From: [Harmon Rita T.](#)
To: [Scott J. Steffen \(ssteffen@bhinc.com\)](#); [Rick Beltramo \(rbeltramo@gcinm.com\)](#)
Subject: C09D011_PP_Appr : Valle Prado Unit 4 and 5 Stamp Date 1-8-2016
Date: Friday, February 12, 2016 3:41:55 PM

VALLE PRADO
UNIT 4
GRADING PLAN

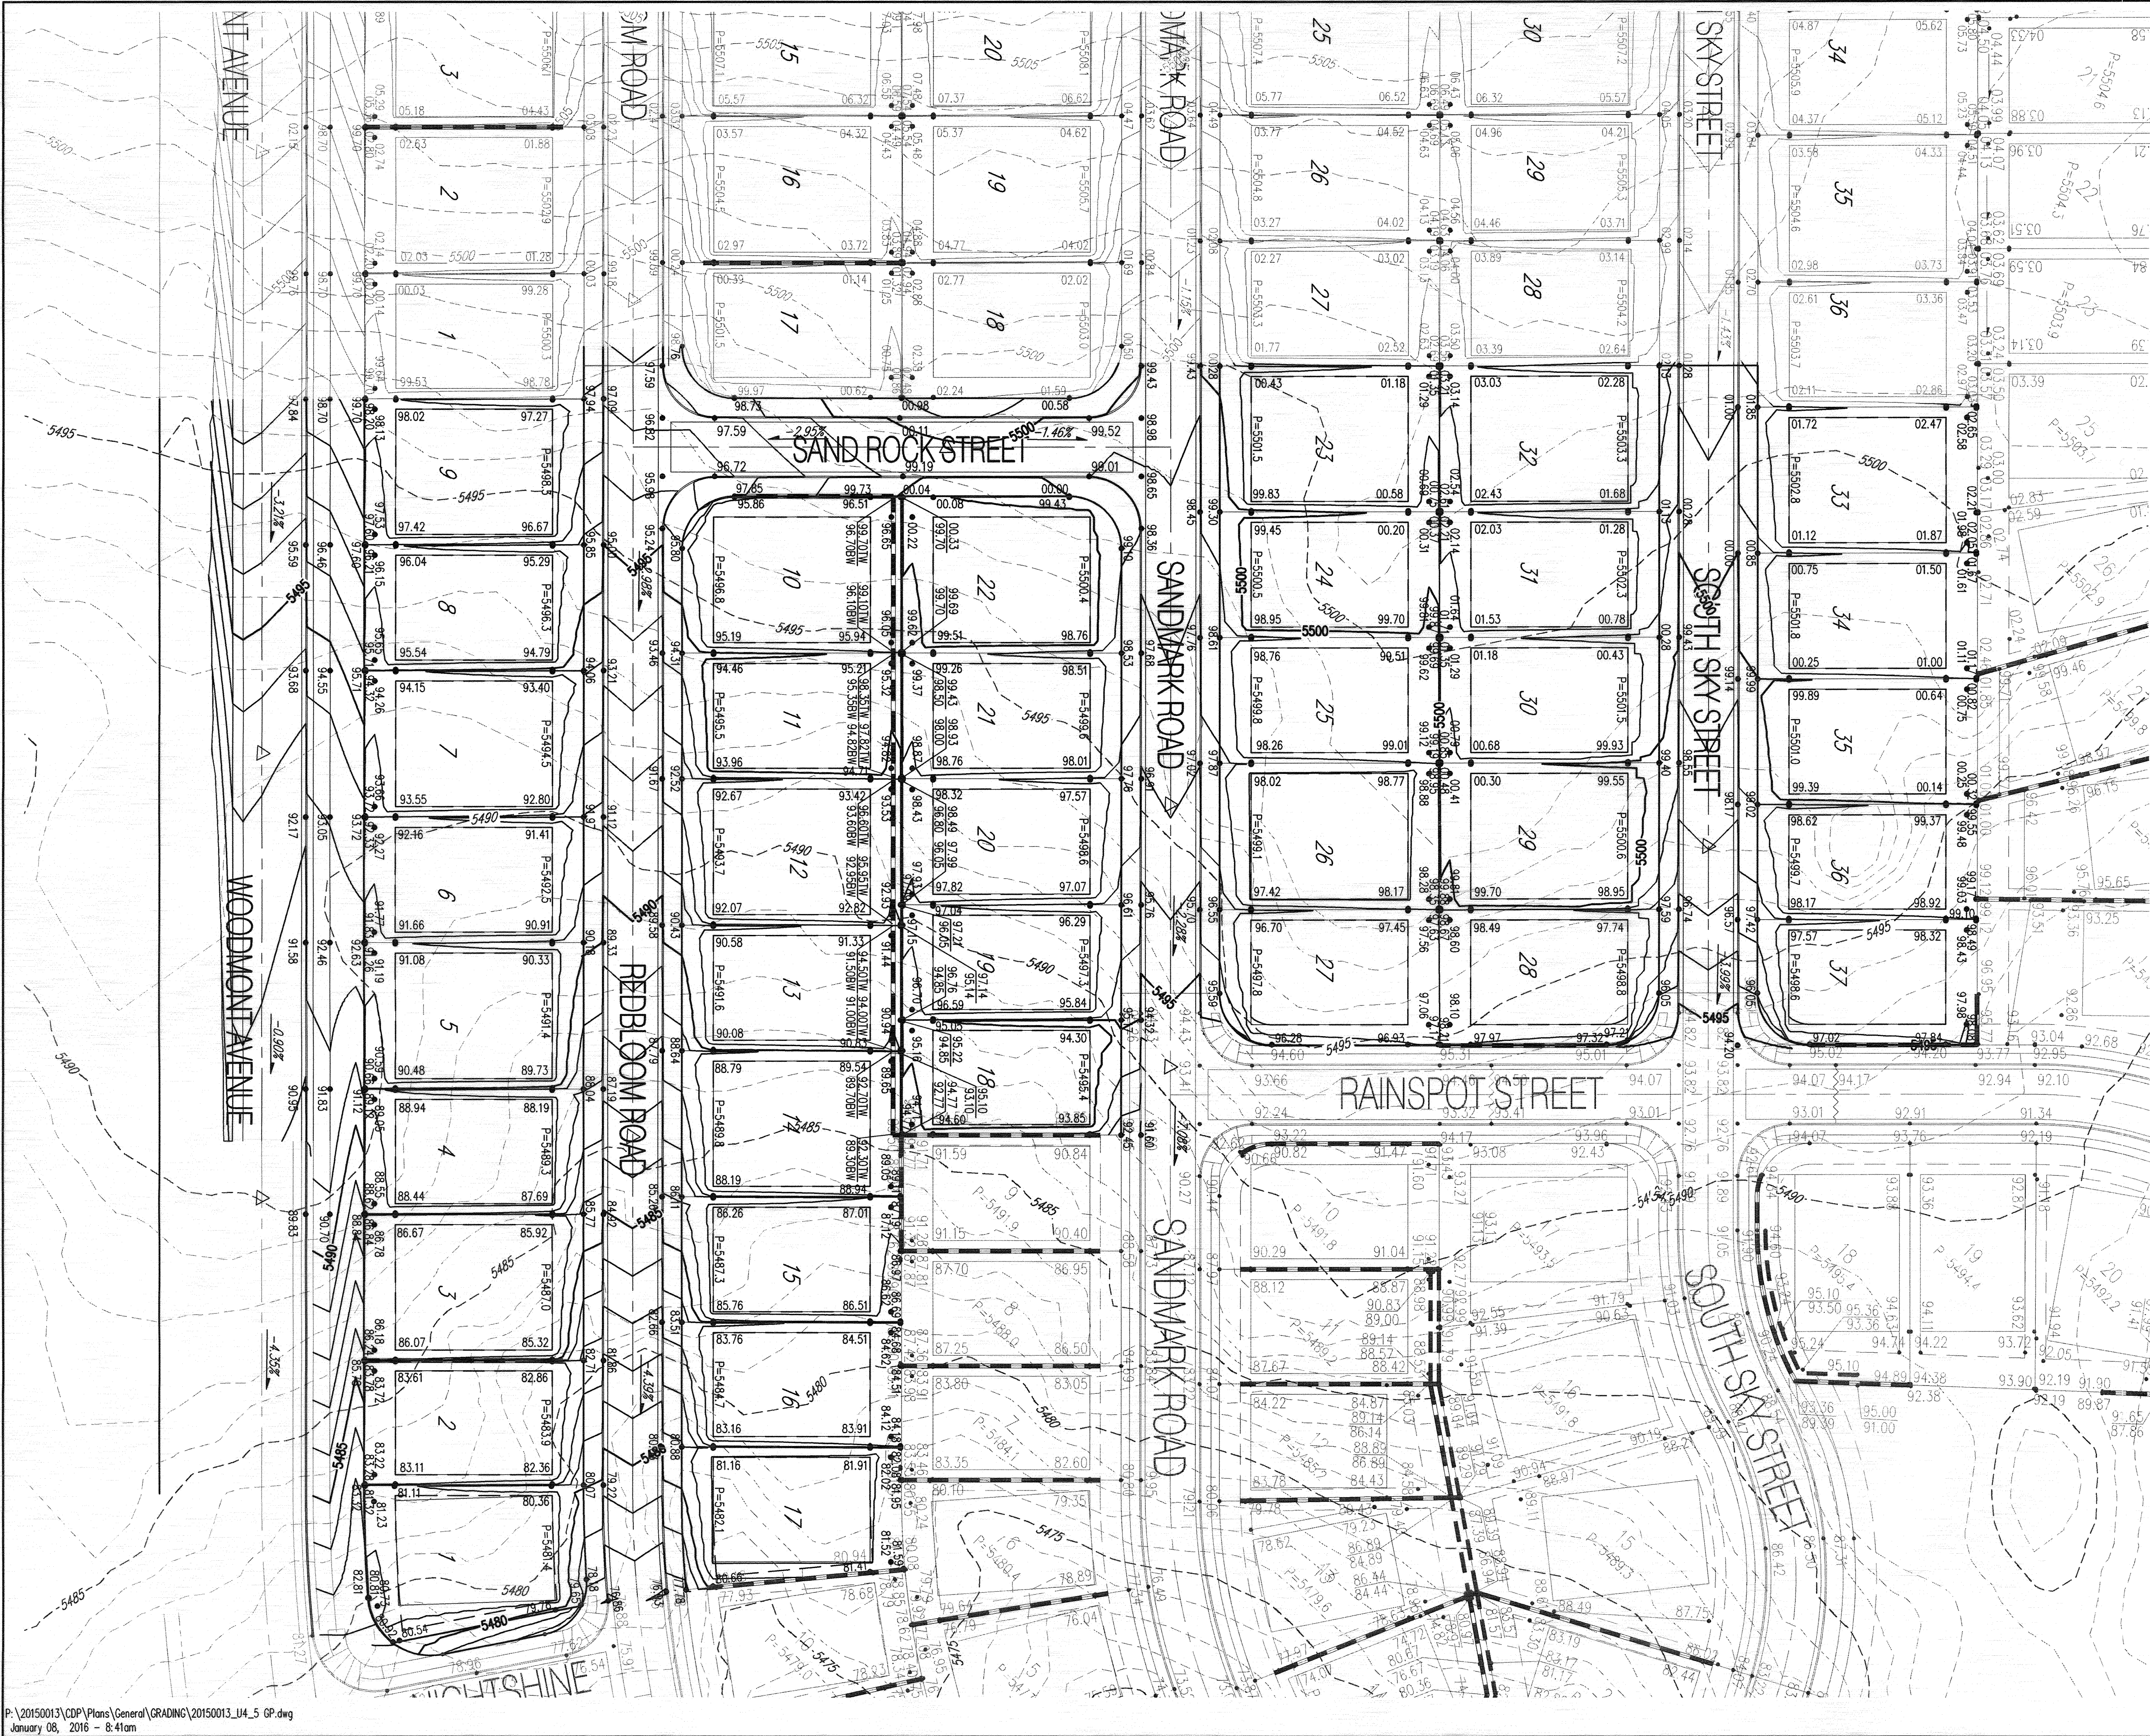
- Interim Grading Plan for Unit 4 is needed showing Temporary Sedimentation Ponds.
- Unit 5 should show a sedimentation pond at the west end of Woodmont Avenue.

- Both Units 4 and 5 should show the As-built elevations roads, pads, etc. of Valle Prado Unit 2 and 3.
- Include in the Infrastructure List Pond A5 (With Agreements and Covenants) and the Retaining wall on east side of Sand Rock Street .
